Application Serial No. 10/625,287
Reply to Office Action of November 28, 2005

Amendments To The Drawings

The attached sheets of drawings implement changes to FIGS. 3-9.

FIG.3 BEST AVAILABLE COPY

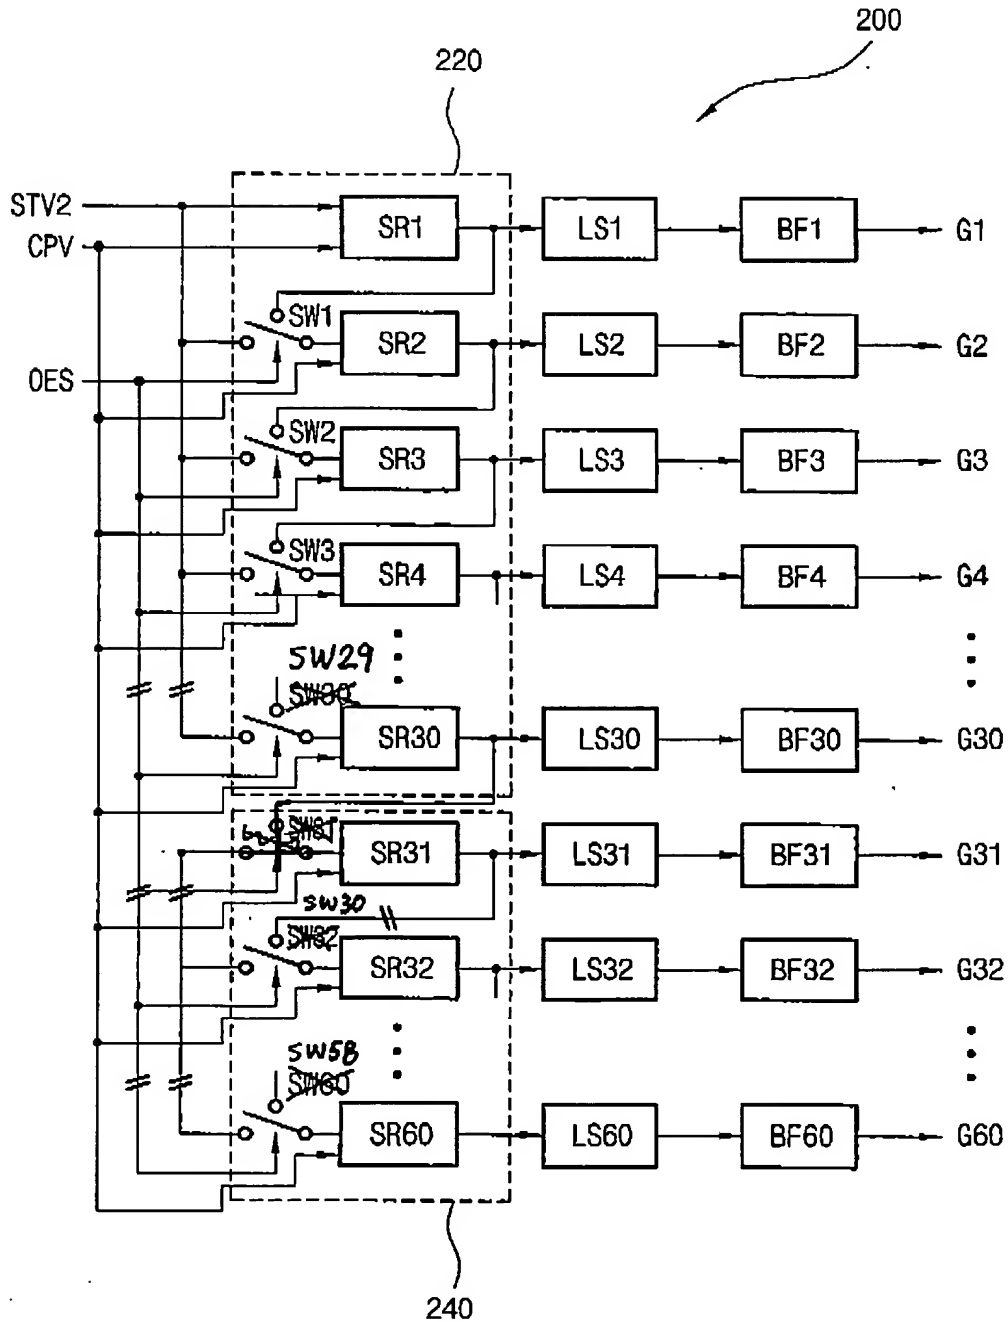
FIG. 4 has been amended to show the ground at the node of R1 and C1. FIGS. 5 and 7-9 have been amended to correct the spelling of "V_sync". Since the changes made in FIGS. 4-5 and 7-9 are easily identifiable, annotated sheets showing the changes to FIGS. 3 and 6 are attached hereto.

In the office action, the Examiner objected to FIGS. 3, 4 and 6 of the above-identified application as having various informalities identified on page 2 of the Office Action. In response, FIGS. 3-4 and 6 have been appropriately amended according to the disclosure of the present invention without adding new matter. Withdrawal of the objection is respectfully requested.
